From: [John Replinger](#)
To: [Kelly Reid](#)
Subject: RE: Public Safety building driveways
Date: Wednesday, May 15, 2019 9:54:16 PM
Attachments: [Linn Ave Access Markup 051519.pdf](#)

I think the right-turn entry on Linn Avenue can be conditionally approved based on the following:

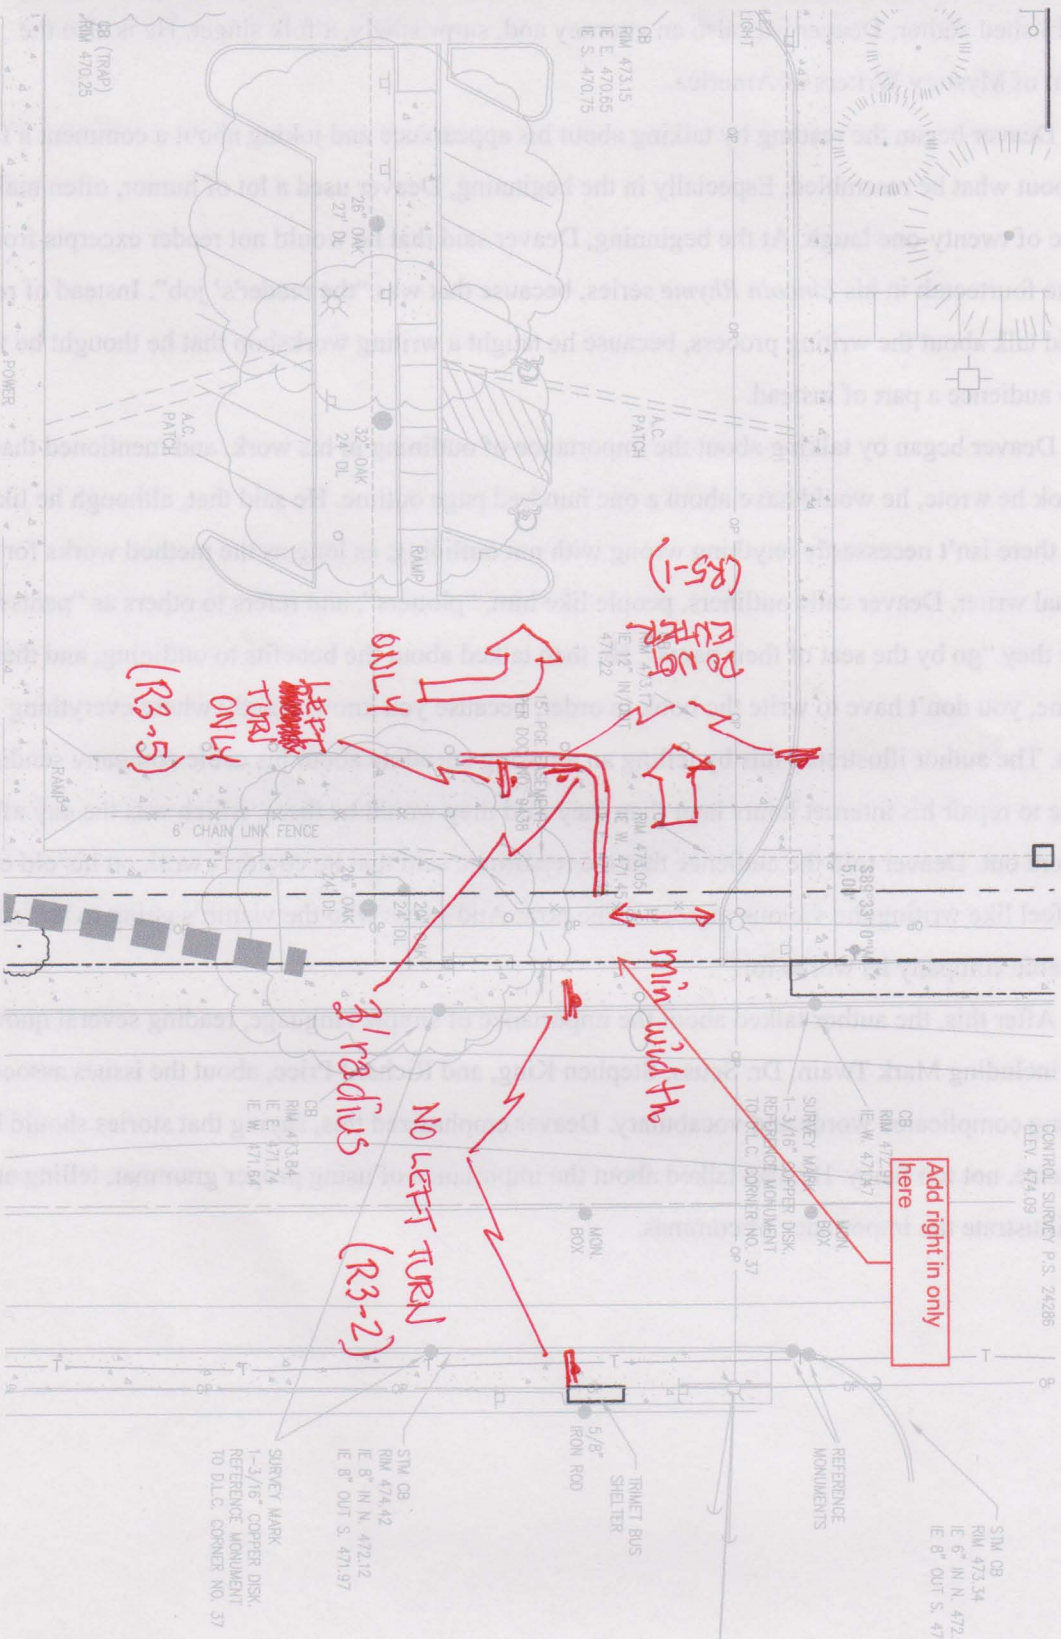
1. Entry width shall be the minimum allowable under the code.
2. Signing shall be installed identifying it as an entry only (i.e. No Left Turn (R3-2) visible from northbound Linn Avenue; Do Not Enter (R5-1) signs from interior of lot; Left turn only from east aisle (R3-5)).

3. Pavement markings in lot show allowable direction of travel for entry; pavement markings in lot show mandatory left turn from easterly aisle of parking lot north of CD office.

4. Where the driveway intersects the east edge of the parking lot, the radius on the south curb line of the driveway and the interior of the parking lot shall be maximum of 3 feet. (This is to discourage right turns from the aisle to the entry only driveway.)

I had difficulty figuring out the curb for the parking lot along Linn Avenue, but I marked up a portion of the site plan to illustrate the above signing, pavement markings, and curb radius recommendations.
